**NOTICE
OSHTEMO CHARTER TOWNSHIP
ZONING BOARD OF APPEALS - REGULAR MEETING**

1. Call to Order
2. Pledge of Allegiance
3. Approval of Agenda
4. Public Comment on Non-Agenda Items
5. Approval of Minutes: August 23rd, 2022
6. **Site Plan – Faraday Defense**
Fishbeck, on behalf of Faraday Properties LLC, is requesting site plan approval for a 60,785 square foot two-story office and manufacturing/distribution facility within the Western Michigan University (WMU) Business Technology Research Park 2.
7. 2023 Meeting Dates
8. Other Updates and Business
9. Adjournment

Memorandum

TO: Oshtemo Township Zoning Board of Appeals
FROM: Kyle Mucha, AICP, Senior Planner
Paul Lippens, AICP, NCI, Vice President
SUBJECT: Faraday Defense – Office & Manufacturing/Distribution Facility – Site Plan Review
DATE: November 8, 2022

STORM WATER MANAGEMENT PLAN

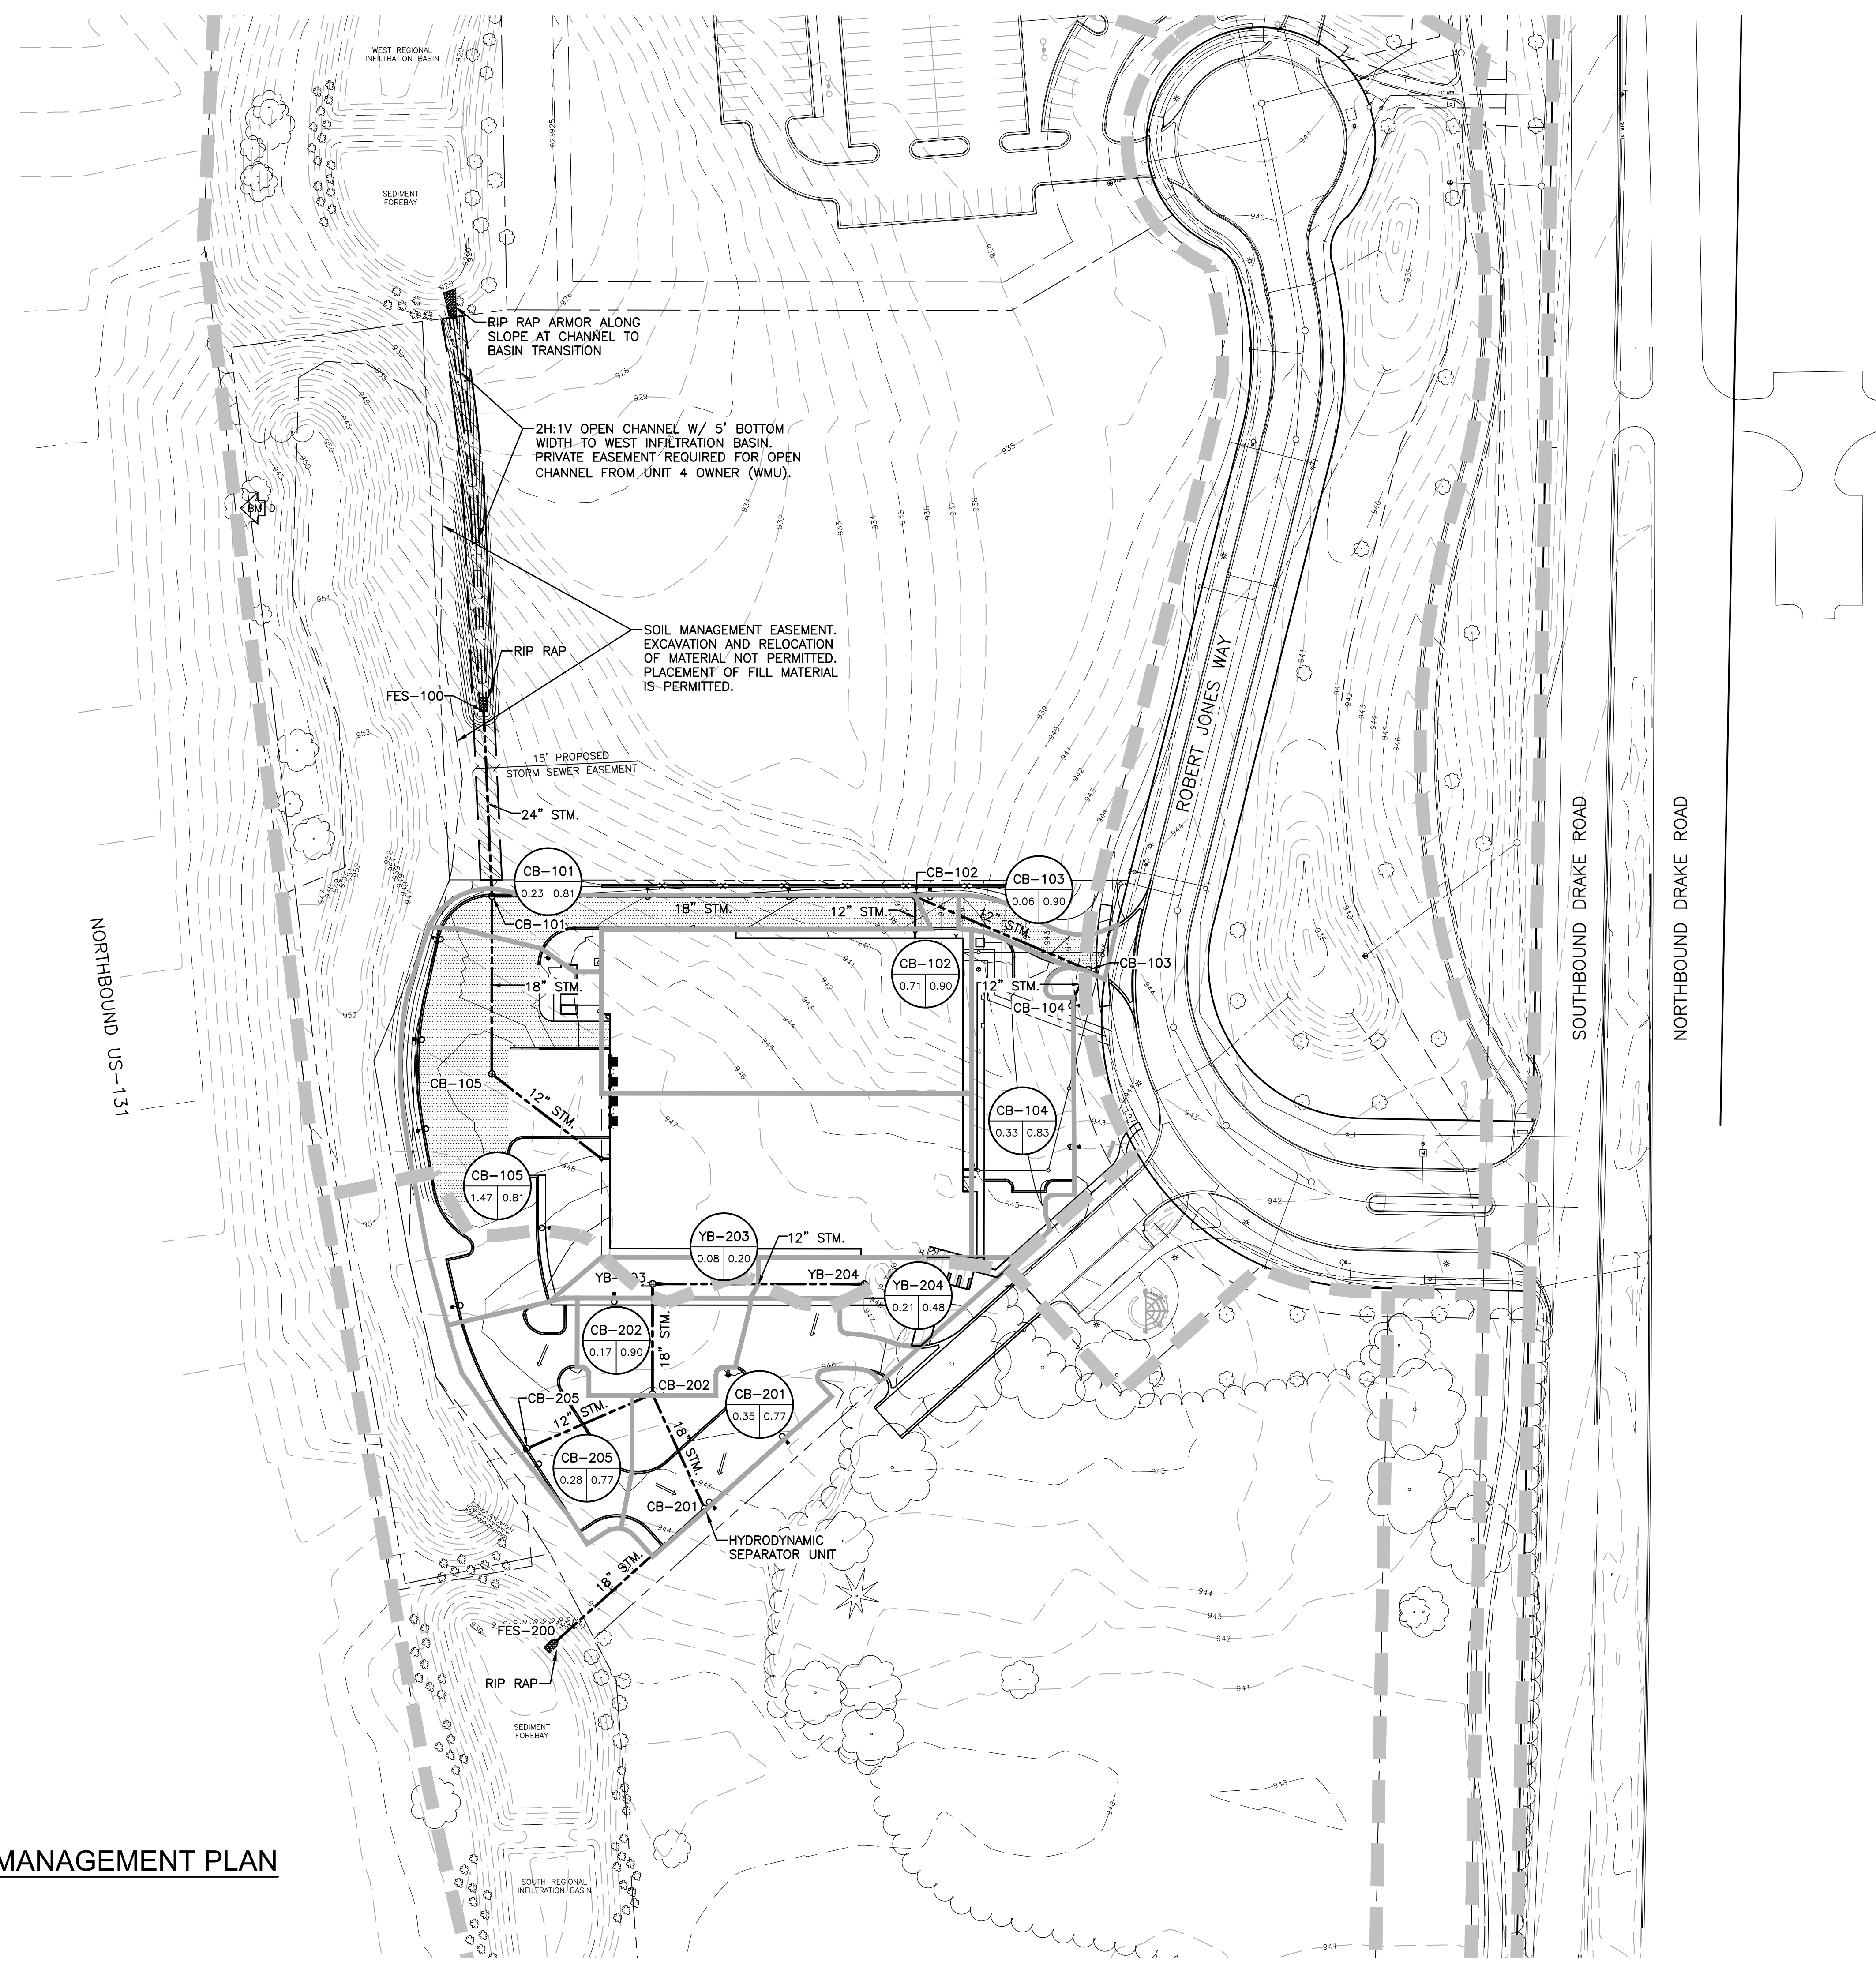
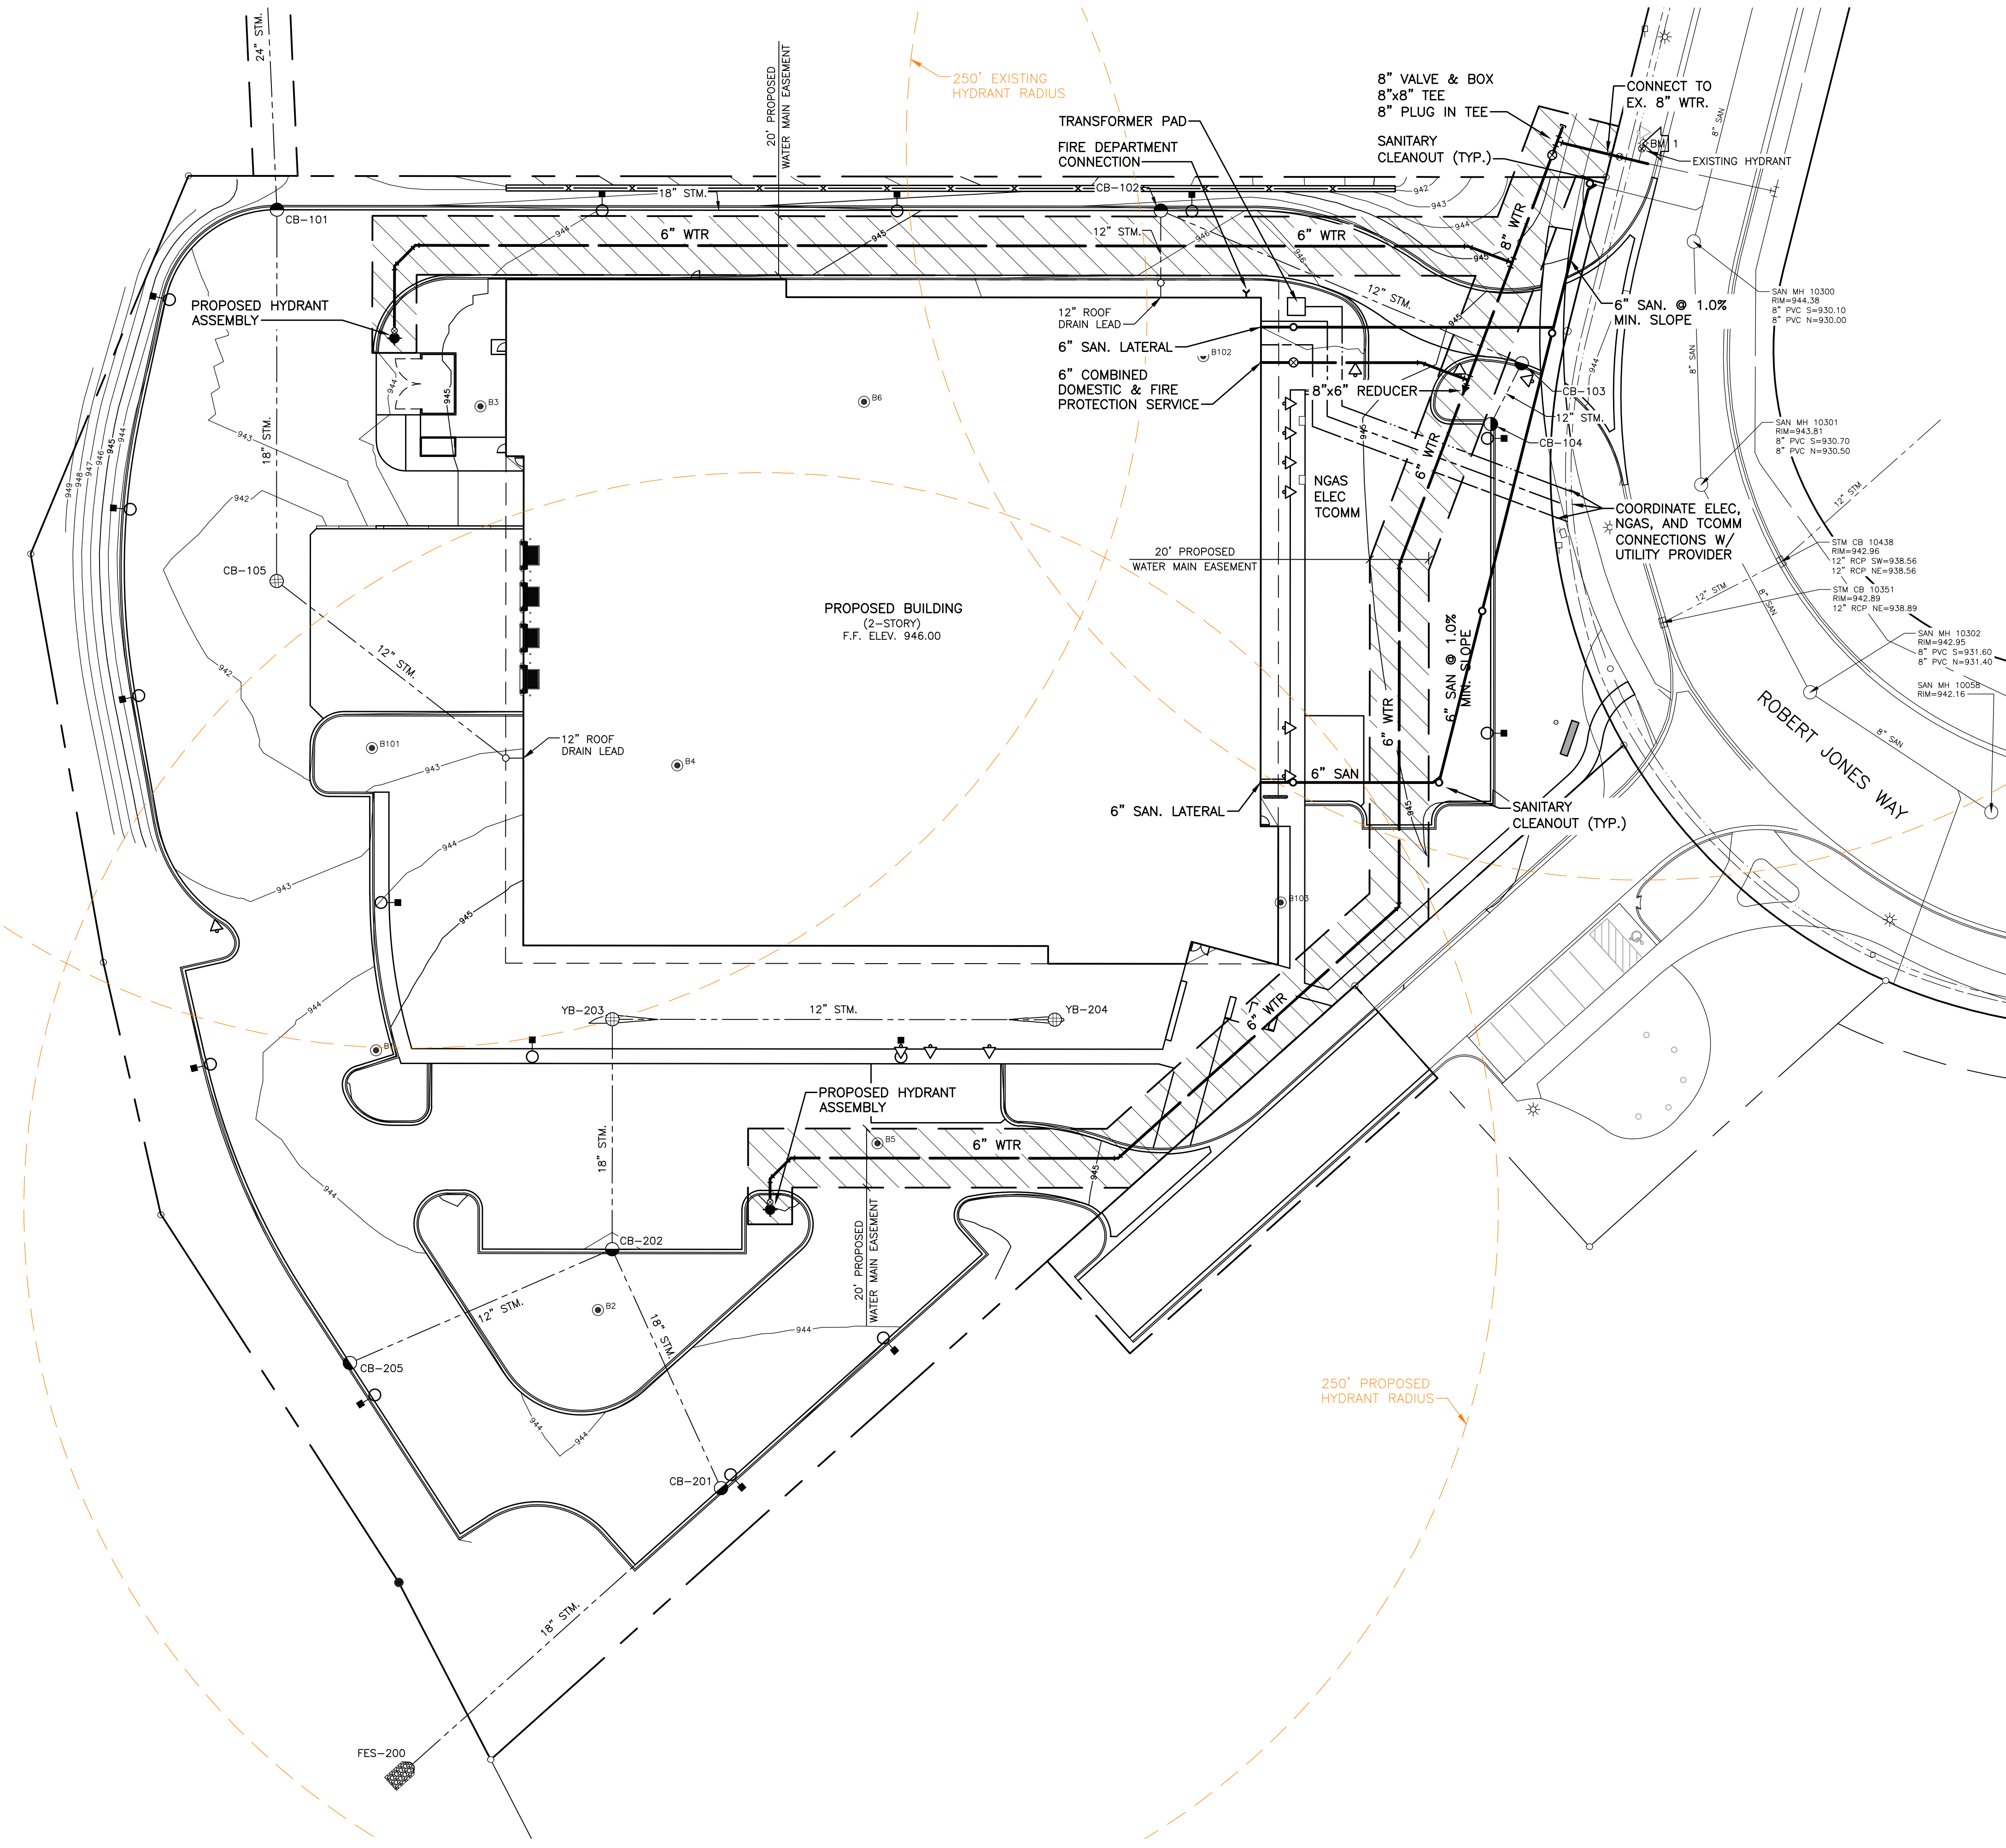
When the BTR 2.0 park was initially created, two stormwater basins were designed and established to serve all development within the park. Contours have been provided which show that this site’s stormwater will be handled appropriately. A final sealed plan, fully detailing grading and drainage is needed prior to building permit issuance.

1. The project site shall be formally established in accordance with the site plan prior to issuance of a building permit.
2. Compliance with Oshtemo Township's Engineering requirements; provide a sealed, final stormwater plan showing grading and drainage prior to building permit issuance.
